Product Discontinuance Notification (PDN)

PDN Number: PTN_WL-SMDC_20270111 Affected Series: WL-SMDC Horticulture Affected Part Number: 150353DS74500, 150353HS74500, 150353FS74500 PDN Date: 2026-07-10 (YYYY-MM-DD) Effective Date: 2027-01-11 (YYYY-MM-DD) Last Order: 2027-01-11 (YYYY-MM-DD) Last Shipment: 2027-07-09 (YYYY-MM-DD)	Change Category: ☒ End of Life
Contact: Product Management Phone: +49 (0) 7942 - 945 5001 Fax: +49 (0) 7942 - 945 5179 E-Mail: pcn.eisos@we-online.com	Attachment: ☐ Yes ☒ No

150353DS74500A (new)

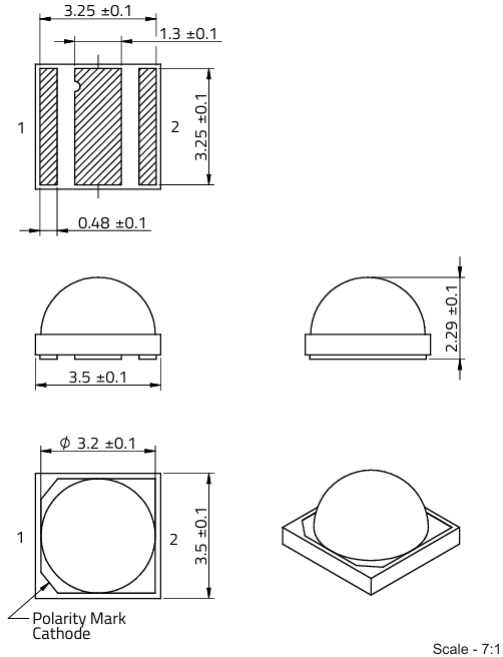
As a replacement, Würth Elektronik will introduce a new generation of LEDs. The discontinued parts will be succeeded by the following part numbers: 150353DS74500A, 150353HS74500A, 150353FS74500A.

Partnumber	Test current [mA]	Forward Voltage [V]	Output [µmol/s]	Efficiency [µmol/J]
150353DS74500 (affected)	350	3,2	4,2	1,7
150353DS74500A (new)	700	2,9	5,3 +26,2%	2,6 +52,9%
150353HS74500 (affected)	350	2,2	4,9	2,6
150353HS74500A (new)	700	1,9	5,8 +18,4%	4,4 +69,2%
150353FS74500 (affected)	350	1,8	1,9	3,1
150353FS74500A (new)	350	2,1	2,4 +26,3%	3,2 +3%

150353HS74500 (affected)

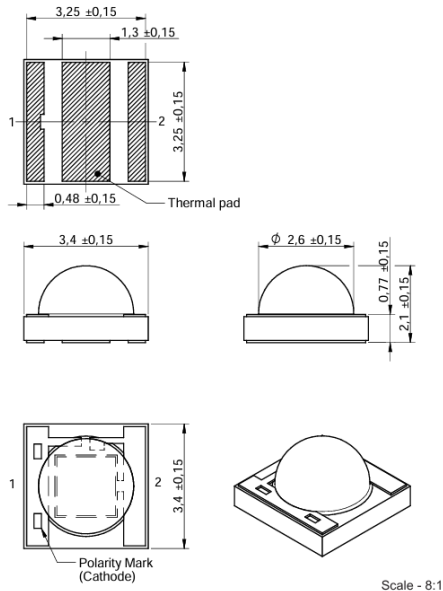
Due to a realignment of the product portfolio, Würth Elektronik eiSos will discontinue the following part numbers: 150353DS74500, 150353HS74500, 150353FS74500.
